Category S	Repair Guidance	Ref. No. R026/17	Page 1 of 3
Coverage <input type="checkbox"/> Distributor only <input checked="" type="checkbox"/> Please inform your dealers		Date Issued April 13, 2017	
Please convey this information to your <input type="checkbox"/> Director <input checked="" type="checkbox"/> General Manager <input checked="" type="checkbox"/> Warranty Dept. <input checked="" type="checkbox"/> Parts Dept. <input checked="" type="checkbox"/> Training Dept. <input checked="" type="checkbox"/> Field Rep.		Date Revised	
Applicable Model MX-5 (ND)	Applicable Countries and/or Vehicle Specifications Worldwide

Subject: Corrosion on Front Door Quarter Glass Guide at where it contacts Beltline Molding

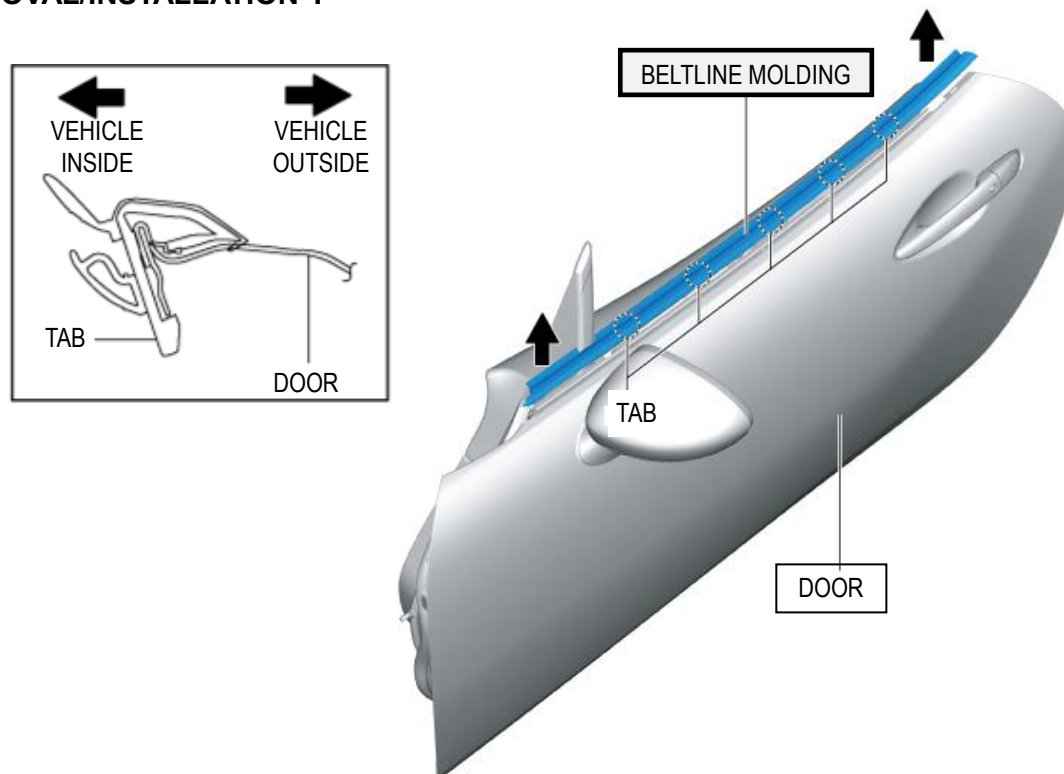
Some vehicles may exhibit Corrosion (A) on the front door quarter glass guide (B) at the point where it contacts the door beltline molding (C).

This concern is caused by the beltline molding contacting the quarter glass guide due to production variances. The paint on the quarter glass guide then gets damaged by vibration during the door closing and the vehicle driving.

A spacer has been attached to the concerned area of beltline molding to assure an appropriate clearance between the beltline molding and the quarter glass guide.

1. Replace the affected side front beltline molding(s) with a modified one(s) according to the procedure in the workshop manual **“FRONT BELTLINE MOLDING REMOVAL/INSTALLATION”**.
